QUESTIONS AND ANSWERS

COMPETITION FOR CONCEPTUAL URBAN AND ARCHITECTURAL DESIGN OF *INDEPENDENCE SQUARE* IN PODGORICA

Capital city Podgorica
Njegoševa 13, Podgorica
Crna Gora
www.podgorica.me

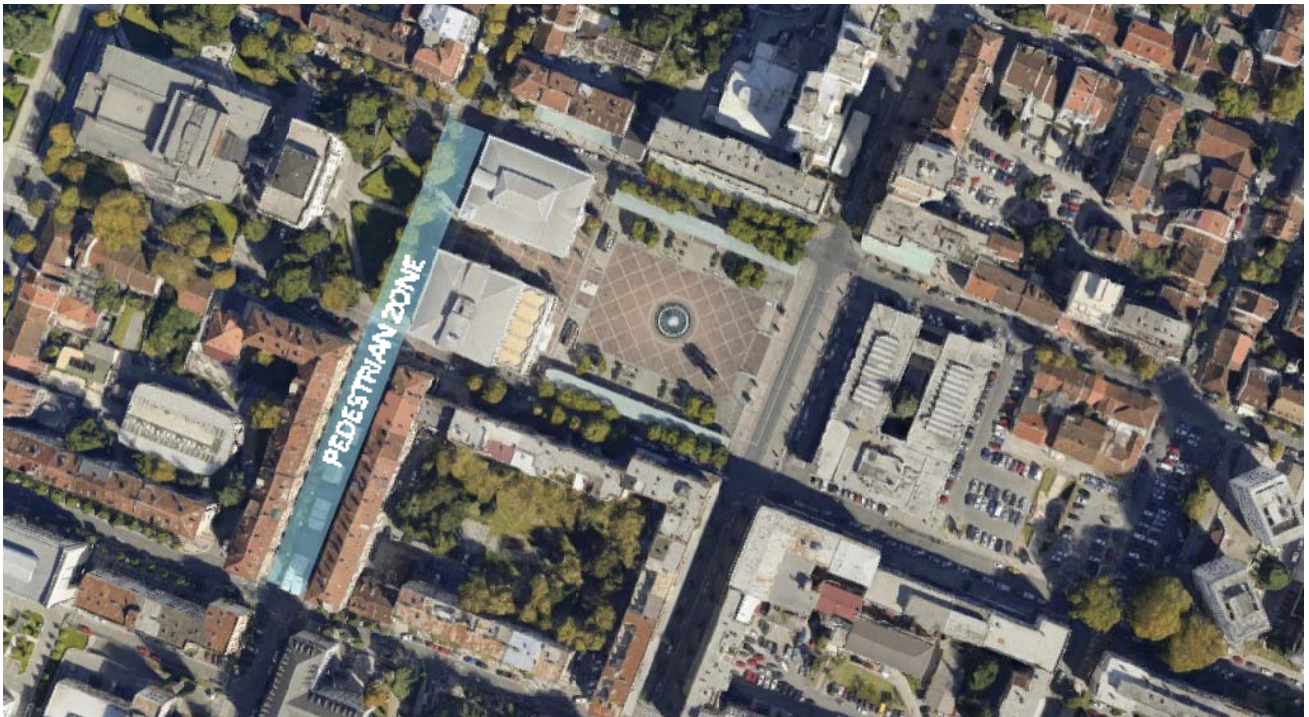
2. ***Who owns the parking lot between the BEKO department and the skyscrapers designed by the architect Stanko Fabris?***

The parking space is owned by Capital city Podgorica.
